G. R. SUBDIVISION

APPLICATION NUMBER 11 DATE June 6, 2013
APPLICANT G. R. Subdivision
REQUEST Subdivision

DETAIL SITE PLAN

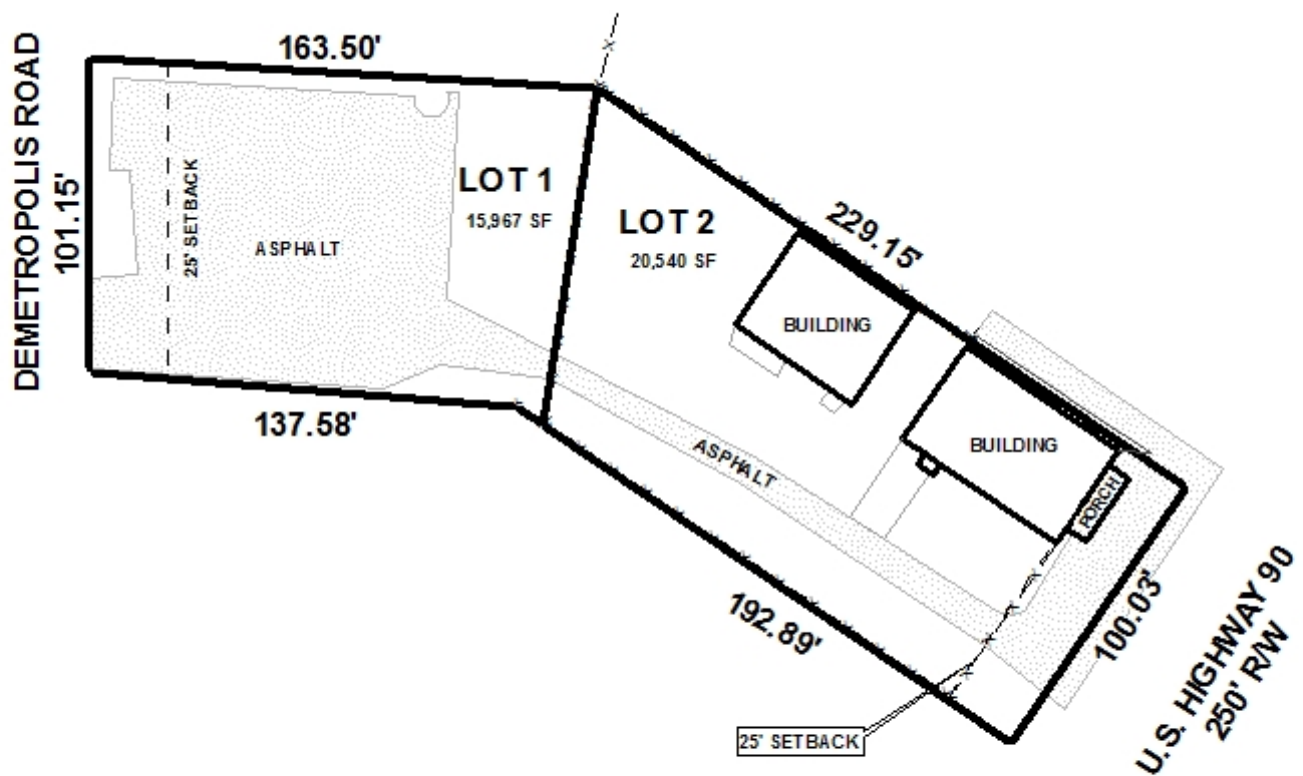
2. Show width of the asphalt drives connecting to LOT 2 and connecting to the adjacent property to the north along Demetropolis Rd.
3. Add a note to the Plat stating that storm water detention will be required for any future addition(s) and/or land disturbing activity in accordance with the Storm Water Management and Flood Control Ordinance (Mobile City Code, Chapter 17 , Ordinance #65-007 & #65-045).

Access management is a concern due to the site abutting two major streets. Access to Government Boulevard, as an ALDOT controlled facility due to its also being U.S. Highway 90, should be limited to one curb-cut. Access to Demetropolis Road should also be limited to one curb-cut. The size, design and location of all curb-cuts must be approved by Traffic Engineering and ALDOT (only for Government Boulevard), and comply with AASHTO standards.

The property is commercially developed. Proposed Lot 1 only has remnant asphalt paving on the site, while proposed Lot 2 has two existing buildings on the site: it appears that the buildings on the site have existed since the 1970s. Any new construction on proposed Lot 2 may require an application for Planned Unit Development approval if the site will contain more than one building.

The 25-foot minimum building setback line, required in Section V.D.9., is depicted on the preliminary plat and will be required on the final plat, if approved.

- 1) placement of a note on the final plat stating that Lot 1 is limited to one curb-cut to Demetropolis Road, with the size, design and location of all curb-cuts to be approved by Traffic Engineering and comply with AASHTO standards;

- 2) placement of a note on the final plat stating that Lot 2 is limited to one curb-cut to Government Boulevard (U. S. Highway 90), with the size, design and location of all curb-cuts to be approved by Traffic Engineering and ALDOT, and comply with AASHTO standards;

- 3) depiction of the 25-foot minimum building setback line from all street frontages on the final plat, as required by Section V.D.9. of the Subdivision Regulations;
